Access Compliance Report

Public Rights-of-Way

(Curb Ramps)

Intersection ID: 10041482	Main Street: WESTPARK_DR	Cross Street: N/A	Location: NE
ADA ID: E46686C48A02	Ramp Type: PerpDiag	Initial Pass/Fail: Fail	Overall Compliance: No
Severity Score: 37.5			
Codes/Mitigation Info/Possible Solution		Field Measurements/Component Compliance

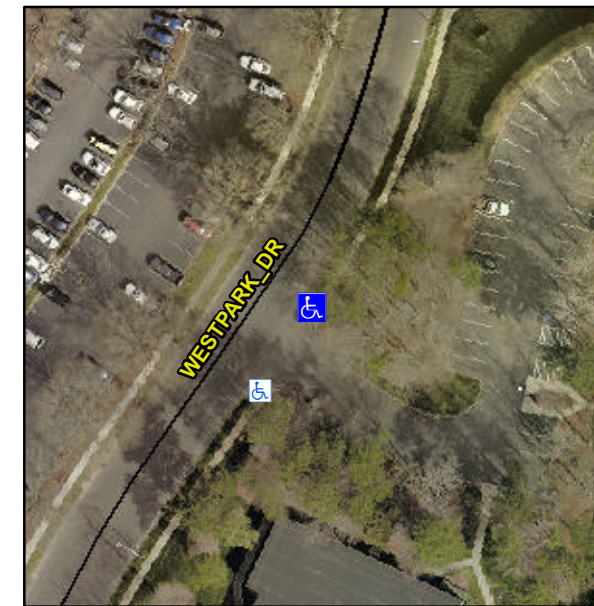
Not Found, R304.2.2, R304.5.3

Compliance	Description	Data	Compliance	Description	Data
N/A	Ramp Length (in)	64.0	No	Ramp Slope (%)	13.8
Yes	Ramp Width (in)	48.0	No	Ramp XSlope (%)	6.0
N/A	Flare Type LT	N/A	N/A	Flare Type RT	N/A
N/A	Flare Slope LT (%)	N/A	N/A	Flare Slope RT (%)	N/A
N/A	Flare Traversable LT?	N/A	N/A	Flare Traversable RT?	N/A
N/A	Landing Length (in)	N/A	N/A	DWS Provided?	N/A
N/A	Landing Width (in)	N/A	N/A	DWS Contrast?	N/A
N/A	Landing Slope (%)	N/A	N/A	DWS Length (in)	N/A
N/A	Landing X Slope (%)	N/A	N/A	DWS Full Width?	N/A
N/A	Landing Curb? (Y/N)	N/A	N/A	DWS Offset (in)	N/A
N/A	Shared Landing?	N/A			
N/A	Gutter Ponding?	Yes	N/A	Gutter Slope (%)	N/A
N/A	Gutter Lip Ht (in)	N/A	N/A	Gutter X Slope (%)	N/A
N/A	Painted X Walk1?	No	N/A	Painted X Walk2?	No
	X Walk 1 Direction	To NW		X Walk 2 Direction	To SW
N/A	X Walk 1 Width (in)	N/A	N/A	X Walk 2 Width (in)	N/A
	X Walk 1 Slope (%)	2.6		X Walk 2 Slope (%)	2.6
	X Walk 1 X Slope (%)	0.3		X Walk 2 X Slope (%)	2.3

N/A	Ramp inside XWalk1?	N/A	N/A	Ramp inside XWalk2?	N/A
	Road Slope (%)	3.7	N/A	Clear Space?	N/A
	Road X Slope (%)	0.5	N/A	Clear Space to XWalk (in)	N/A
N/A	Any Obstructions?	N/A	N/A	Storm Grate/Utility Hazard?	N/A
	Obstruction Type			Storm Grate/Utility Type	
		N/A			N/A
		Yes		Surface Condition? (G/P)	Good

Remove & Replace Curb Ramp With Two New Directional Ramps or Equivalent.
